DEVELOPMENT APPLICATION ASSESSMENT REPORT

Application Number:	DA2022/1586	
	•	
Responsible Officer:	Phil Lane	
Land to be developed (Address):	Lot 31 DP 11423, 9 Kananook Avenue BAYVIEW NSW 2104	
Proposed Development:	Alterations and additions to a dwelling house	
Zoning:	C4 Environmental Living	
Development Permissible:	Yes	
Existing Use Rights:	No	
Consent Authority:	Northern Beaches Council	
Land and Environment Court Action:	No	
Owner:	Daniel Brian Finch	
	Vanessa Ann Finch	
Applicant:	Rapid Plans Pty Ltd	
Application Lodged:	04/10/2022	
Integrated Development:	No	
Designated Development:	No	
State Reporting Category:	Residential - Alterations and additions	
Notified:	11/10/2022 to 25/10/2022	
Advertised:	Not Advertised	
Submissions Received:	3	
Clause 4.6 Variation:	Nil	
Recommendation:	Approval	
	·	
Estimated Cost of Works:	\$ 230,560.00

Original plans

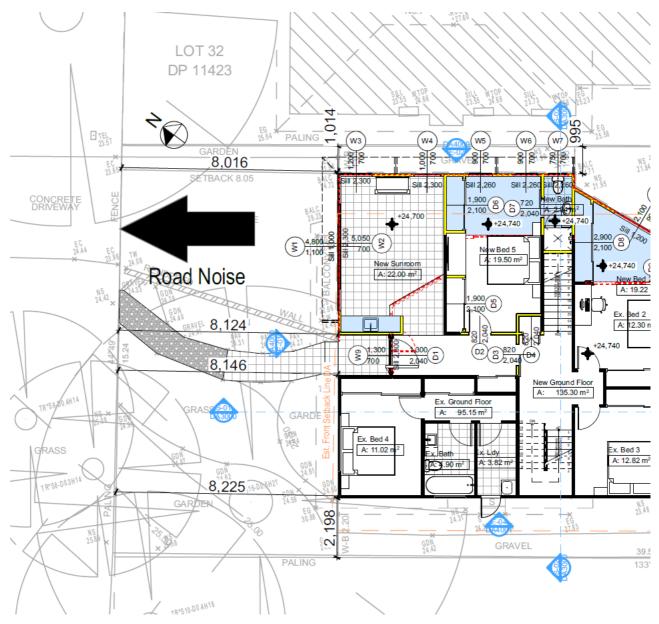
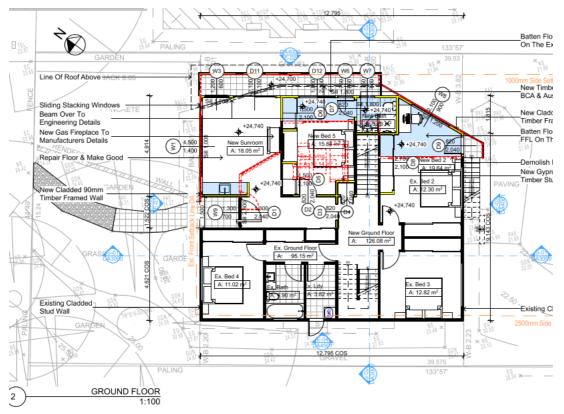
Amended plans were received by Council on 28 August 2023 from the applicant which increased the side setback of proposed enclosure of the existing ground floor (see below). The original plans totally enclosed the existing balcony with only a 0.995m - 1.014m side boundary setback to these proposed new works. The amended plans have now increased the side setback of the enclosed works to over 2m with the existing balcony to remain on along the eastern side setback area providing sufficient visual relief and acoustic privacy.

Amended Plans submitted 28 August 2023 with increased side setback to enclosed works

Figure 3 - Northern elevation with ground floor encroaching the side boundary envelope (original plans)

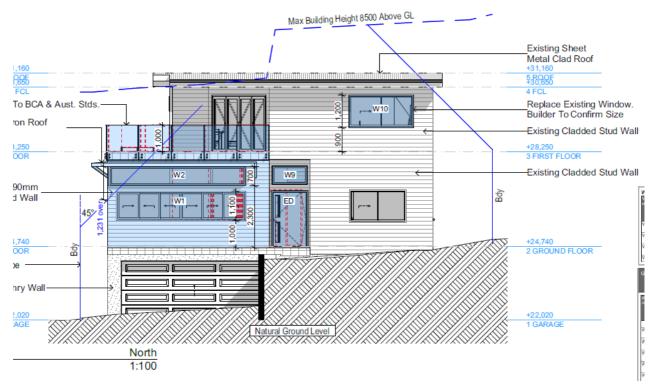
The original plans encroached upon the building envelope (see Figures 3 & 4 below) and with the amended plans submitted on 28 August 2023 with the increased side setback to the enclosed works ensures that the proposed ground floor works do not encroach upon the envelope (see Figures 5 & 6 below).

Figure 7 - Original Stamped Plans for Consent N0199/04

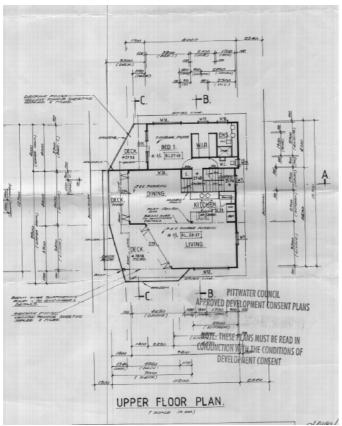
A review of the original plans submitted with current development application (see Figure 7 below) notes that the first floor plan (see Figure 8 below) was incorrect and the amended plans (see Figure 9) submitted on 28 August 2023 has now addressed this concern and is consistent with the original approval granted via Consent - N0199/04 dated 5 August 2004.

Figure 2 - Northern elevation showing envelope breach in purple

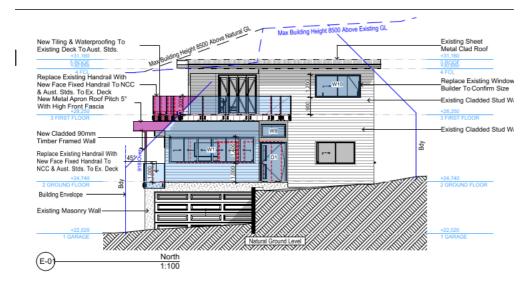
This control requires development to be sited within a building envelope determined by projecting planes at 45 degrees from a height of 3.5m above ground level at the side boundaries. The proposed development presents an encroachment to the northern side boundary envelope as seen below.

The proposed additions retain the side setbacks of the existing dwelling which has contributed to the envelope encroachment. The site topography is steep sloping towards the rear and the eastern side boundary which makes compliance with the envelope challenging. The proposed development is considered to respond to, reinforce and sensitively relate to the spatial characteristics of the existing environment by minimising the extent of the breach.
